Appl. No. 10/801,492  
Amdt. dated March 21, 2006  
Reply to Office Action of February 6, 2006

**Amendments to the Drawings**

The attached sheet of drawings includes changes to Fig. 3A. This sheet, which includes Figs. 3A, 3B and 3C, replaces the original sheet including Figs. 3A, 3B and 3C. In Fig. 3A, previously omitted reference signs 41M, 41C, 41Y and 41K have been added.

FIG. 3 A

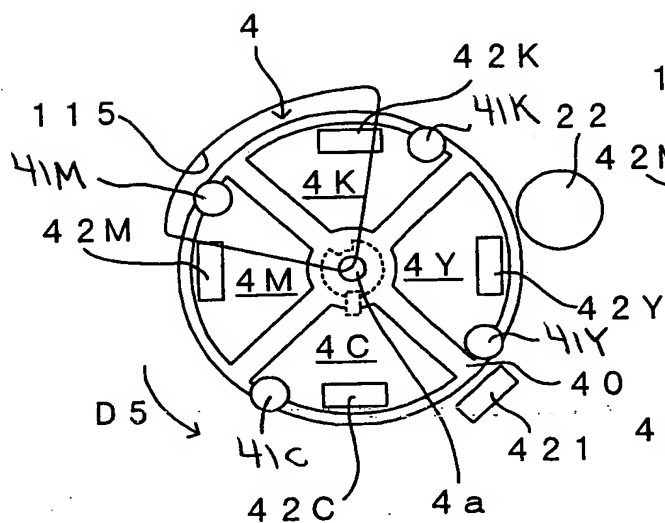
The drawings are objected to under 37 CFR 1.84(p)(5) as not including reference sign 41 mentioned at page 15, line 14 of the specification. In response, the specification is amended to individually refer to developing rollers 41Y, 41C, 41M and 41K, and the group designation "41" is deleted. Fig. 3A is correspondingly amended to include reference signs 41Y, 41C, 41M and 41K to designate the developing rollers.
